HIGHGATE
SOCIETY

3rd March 2024

Re: HGY/2023/2493 –Townsend Yard “Redesign of plot 1 to incorporate fire brigade access to adjacent properties through an alleyway at ground floor level into the rear of the plot.”

Following the Highgate Society’s earlier objection, it is now writing to object to the revised Fire Strategy Report Rev 2 (FSR2) submitted in January 2024 (but dated July 2023) in support of application HGY/2023/2493. While FSR2 primarily deals with fire safety and general fire strategy for the mews, it also addresses the fire safety strategy for the Shepherd’s Cottage (36a Highgate High Street) but does so only briefly under clause 10.7 of the report. This leaves the Society very concerned for the safety of the Cottage and its occupants. The areas of concern are:

Scenario 1 – A fire breaks out in the High Street buildings cutting off the passageway to the High Street.

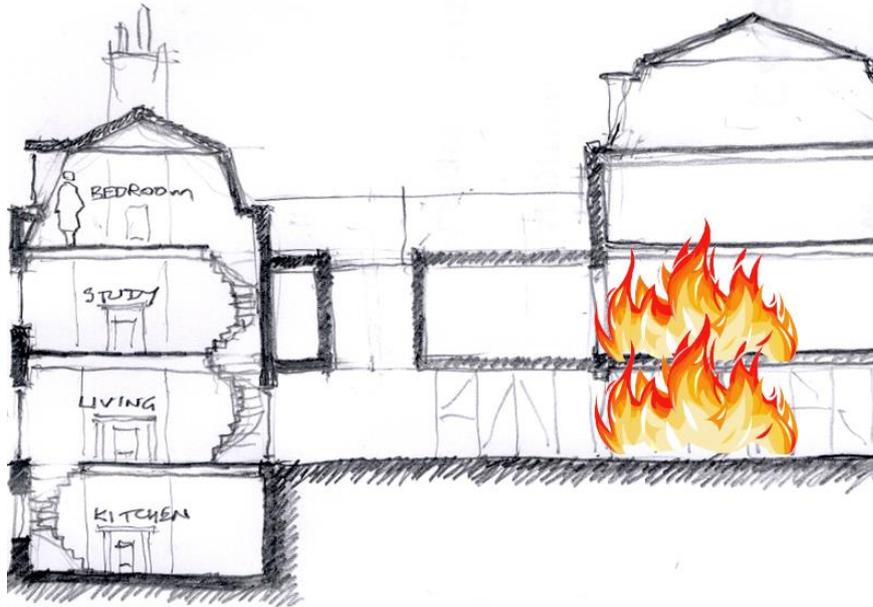
With the wind tunnel effect through the passageway the fire could quickly spread back towards the cottage.

Scenario 2 – A fire breaks out on the lower floors of the cottage.

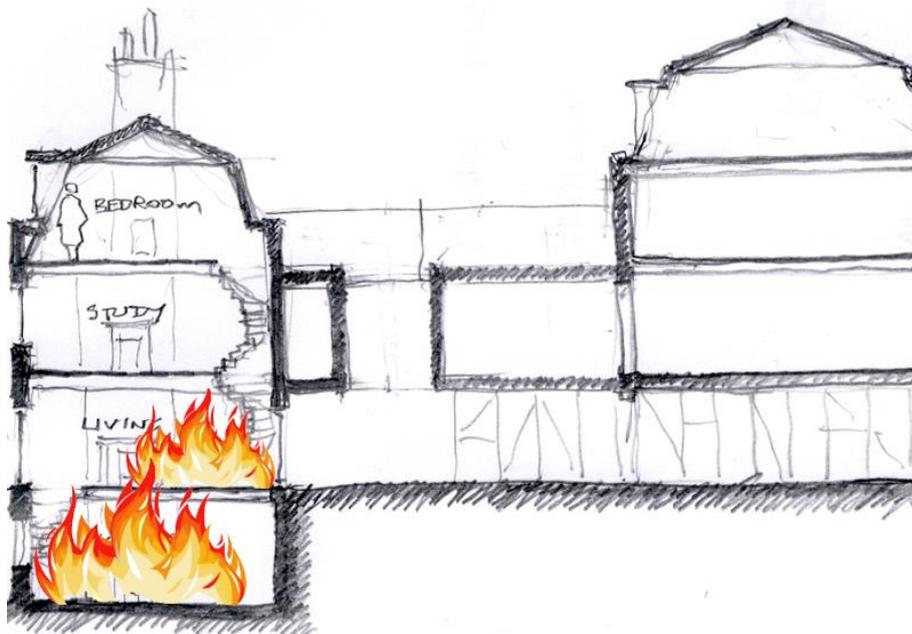
Bear in mind that the cottage is timber framed with no fire separation between floors, open stairs and just floorboards on exposed timber joists. There are open fireplaces on each floor. If a fire were to break out on the lower floors it would quickly engulf the whole house so escape from the bedroom which is on the top floor would have to be through a window and the windows are only on the north side of the cottage facing Townsend Yard.
